REMARKS

I. Response to Drawing Objections

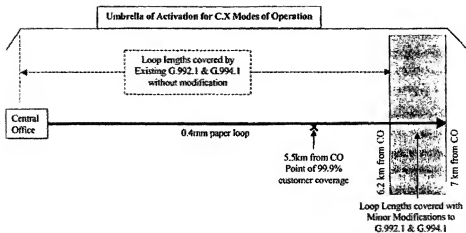
In the Response to Amendment section, the Office Action indicates that Applicants' arguments are not persuasive and maintains the objection to the drawings under 37 CFR 1.83(a). In particular, the Office Action asserts that the implementation of the claimed invention is not shown in the drawings. As noted by the Examiner, the pending claims recite an ADSL system comprising components. Applicants disagree, however, that the apparatus is not shown in the figures. Applicants submit that the claimed embodiments are supported in at least FIG. 2 and the related text. FIG. 2 is reproduced below:

Further, the related text for FIG. 2 states as follows:

Referring now to FIG. 2, there is shown a block diagram illustrating a deployment guideline for ADSL systems implemented in accordance with the present invention.

With respect to the above the following points are to be noted: the CO operator typically has the sole control of the spectrum management, i.e. if the operator does not wish to operate in overlapped mode on its loops plant, the operator needs only to limit the ATU-C transmitter in the manner set forth in additional detail below.

(Paragraph 0176). The claims are generally directed to "An asynchronous digital subscriber line (ADSL) system comprising: a central office (CO) operator configured to perform spectrum management . . ." Applicants submit that the claimed features are supported by the drawings. Based on the foregoing, Applicants respectfully request that the objection to the drawings be withdrawn.
